CRIGLER ADDITION

WICHITA, SEDGWICK COUNTY, KANSAS

Re: S/D 95-80 CRIGLER ADDITION (Final Plat)

STAFF REPORT
(Final Plat Approved 12/7/95)

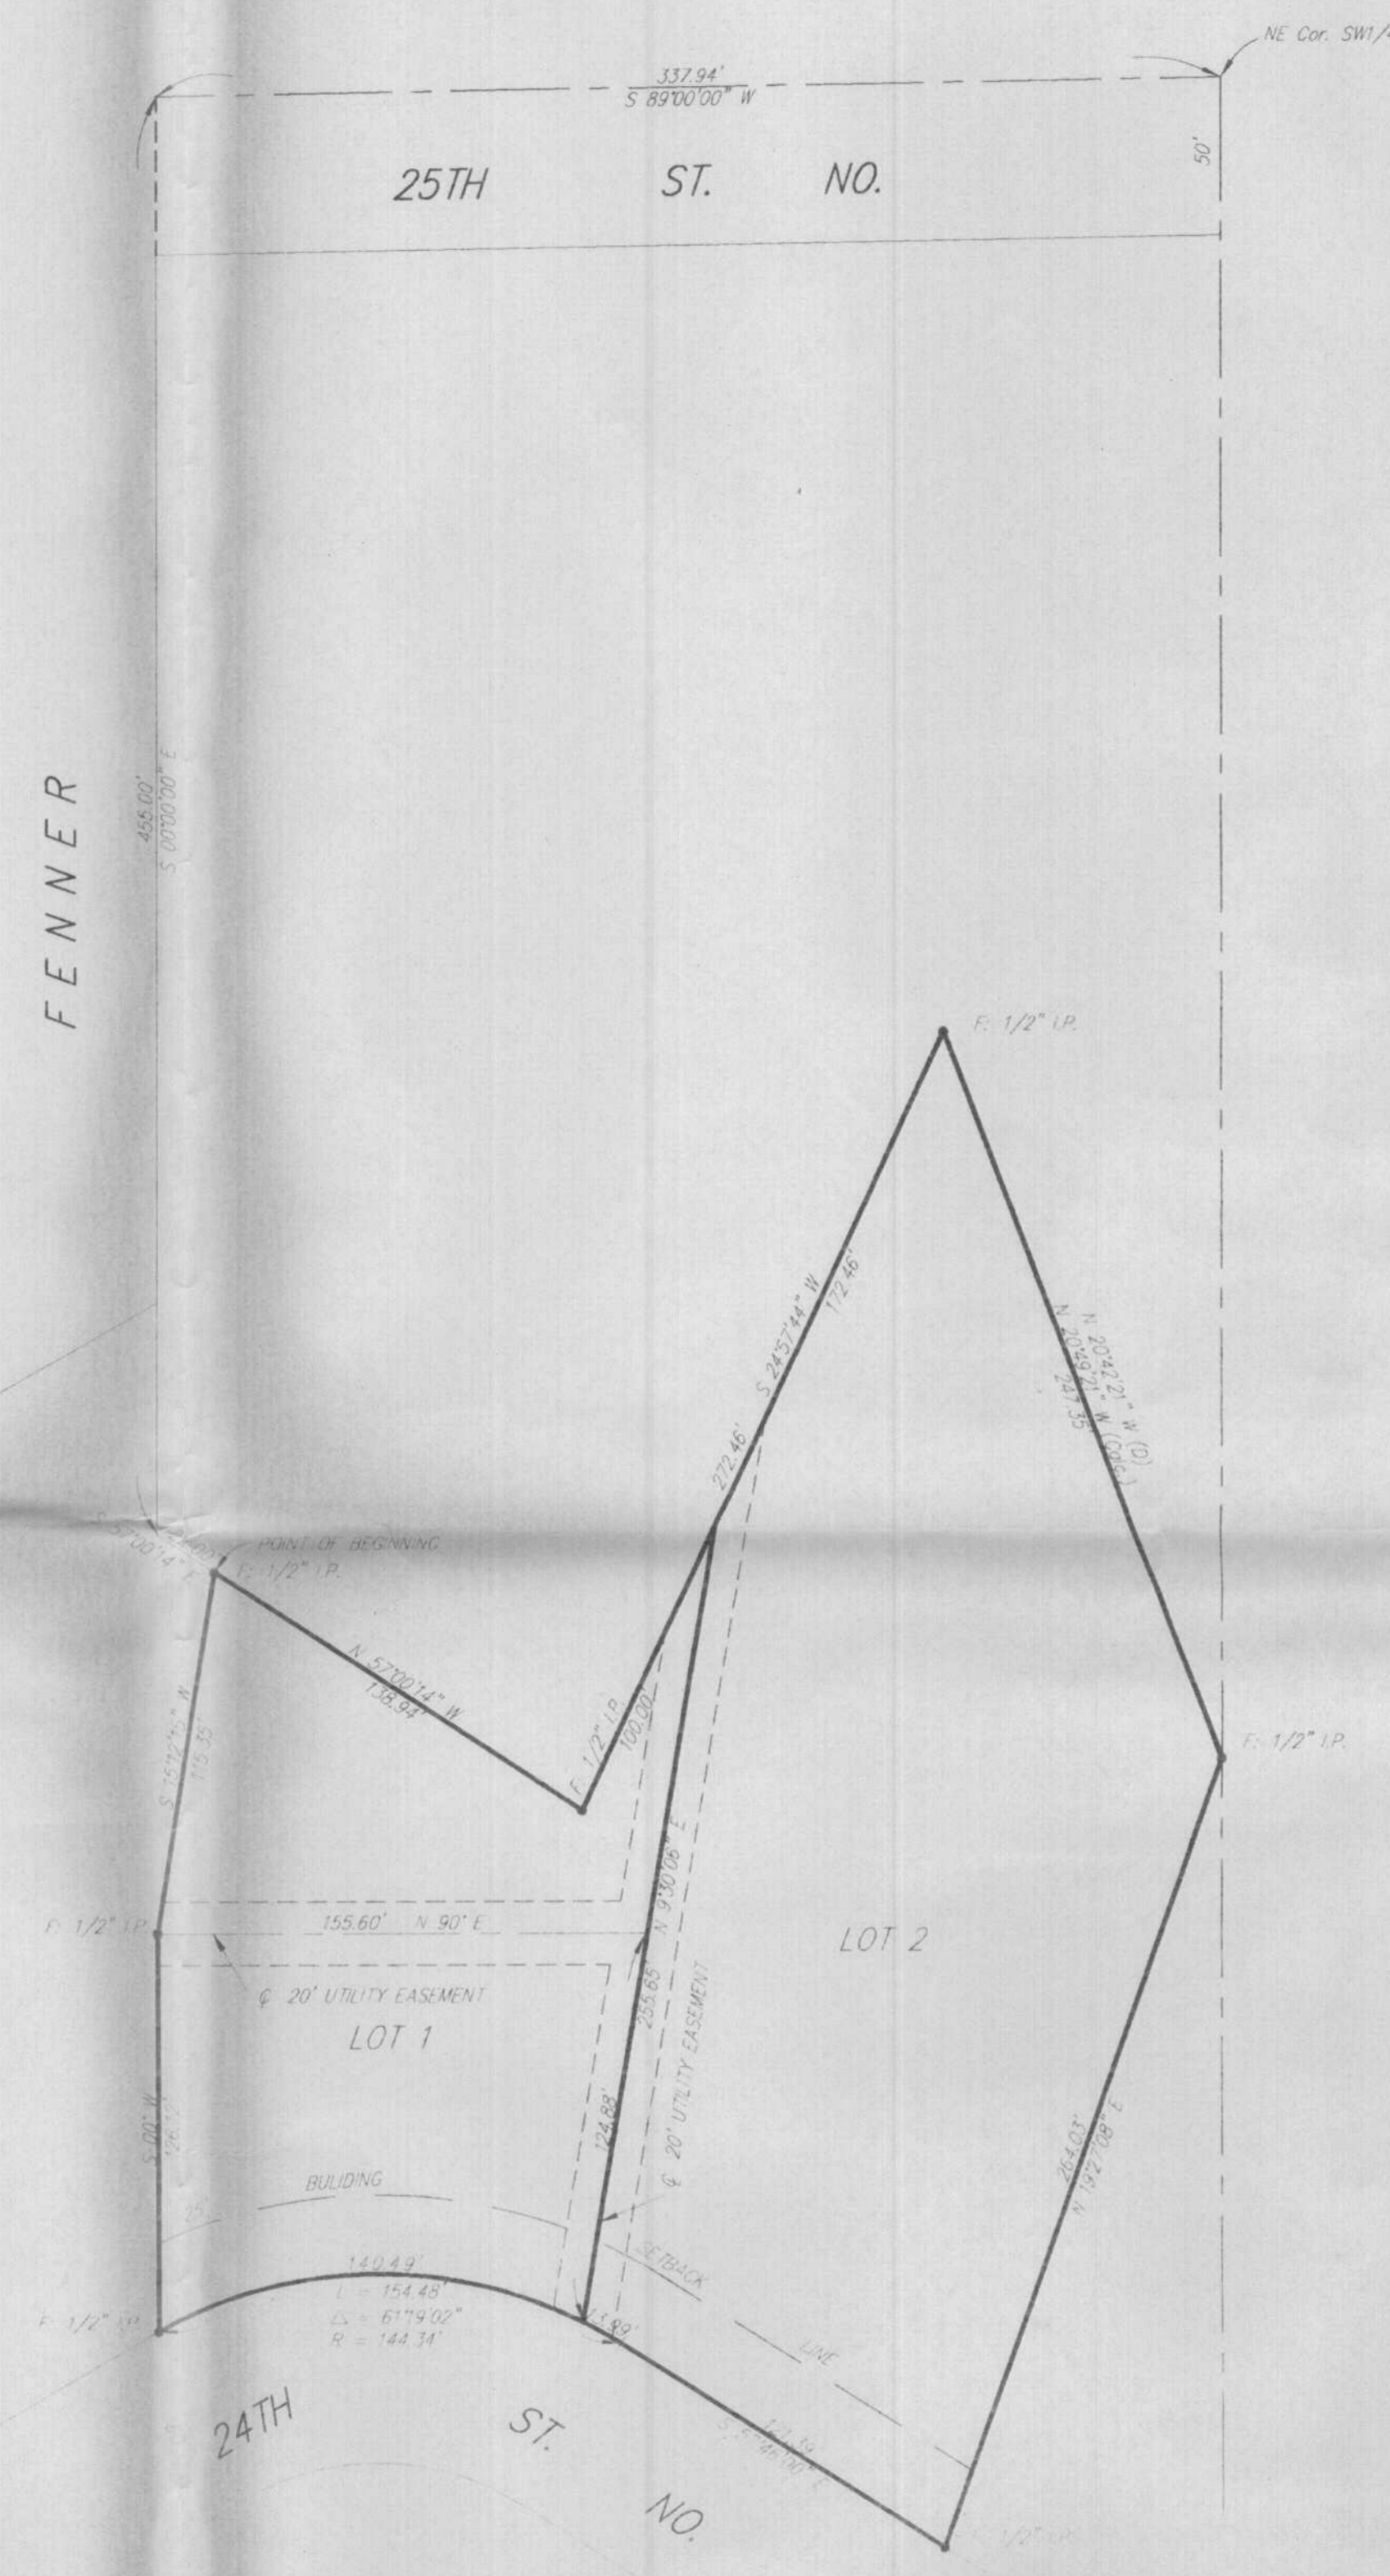
State of Kansas) *as of 3/26/96*
Sedgwick County) *SS Conditions will need to be set on this plat*

Wichita-Sedgwick County Metropolitan Area Planning Commission
this copy is not accurate

- E. On the final plat tracing, the common lot line between Lots 1 and 2 shall be drawn at the same thickness of the other lot lines. As now drawn, it is somewhat uncertain as to line being a lot line or just a center line for the adjacent 20-foot easement.

- F. *don't do - still using tie to sec.*
On the final plat tracing, it appears that a tie point from one of this Addition's lots (Lot 1) can and should be established from an adjacent existing lot.

- G. *still shows Nancy*
On the final plat tracing, the MAPC signature block shall be amended to indicate Susan Osborne-Howes as the chair(man).

- ~~I.~~ The applicant's agent is advised that while the street to the northwest of this site was platted as Ethel, recent maps are showing all or the north-south section as having the name Fenner (Place). The final plat tracing shall correctly indicate the name as Fenner for this street segment.
